The Commission has issued the enclosed Amendment Nos. 62 and 5 to Facility Operating License Nos. DPR-67 and NPF-16 for the St. Lucie Plant, Unit Nos. 1 and 2. These amendments consist of changes to the Technical Specifications in response to your application dated October 12, 1983. As a result of our review, three of your requested changes have been approved and one has been denied.

SAFETY EVALUATION BY THE OFFICE OF NUCLEAR REACTOR REGULATION

SUPPORTING AMENDMENT NOS. 62 AND 5

ST. LUCIE PLANT, UNIT NOS. 1 AND 2

Figure 6.2-2 Unit Organization - St. Lucie Plant, Unit 1

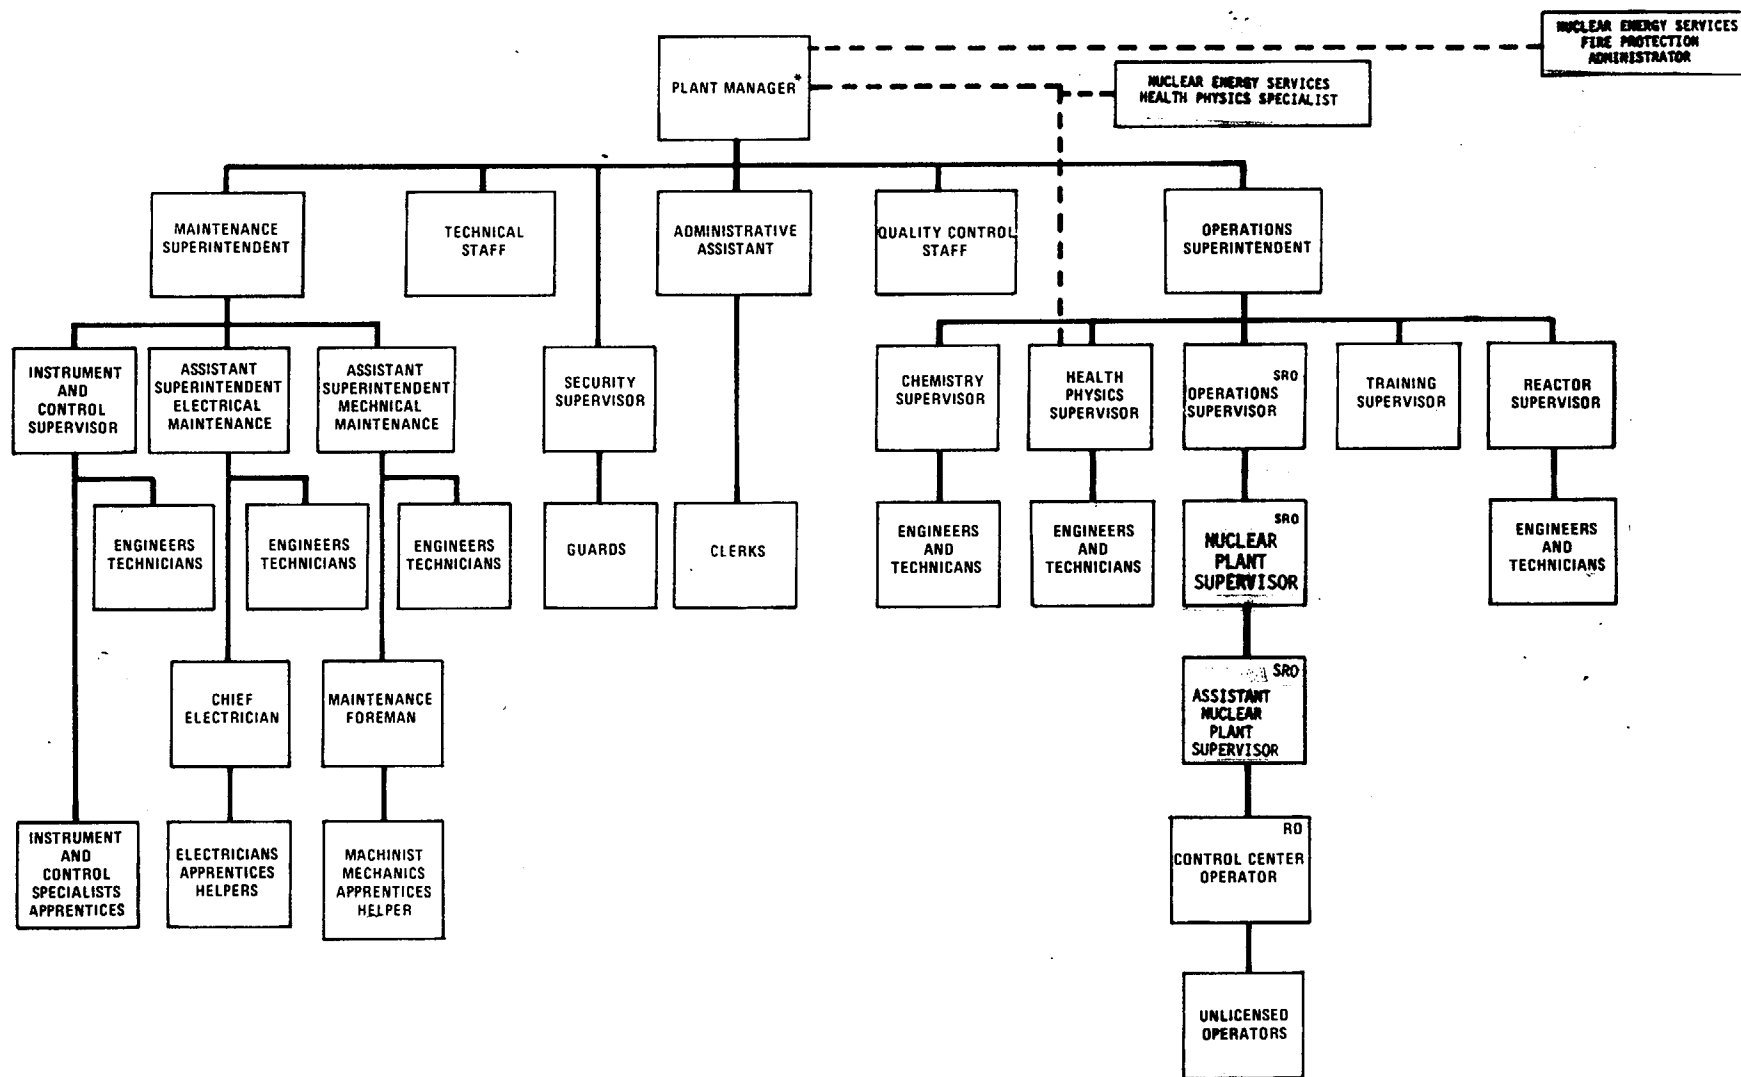
Figure 6.2-2 for each unit is to be revised to change the titles of on-shift personnel to achieve consistency between Unit 1 and Unit 2. Specifically, the Shift Supervisor title on Unit 2 is to be changed to agree to the slightly modified Unit 1 title of Nuclear Plant Supervisor. For both units the title of Watch Engineer is changed to Assistant Nuclear Plant Supervisor. The staff finds that these changes in title are administrative in nature and are acceptable.
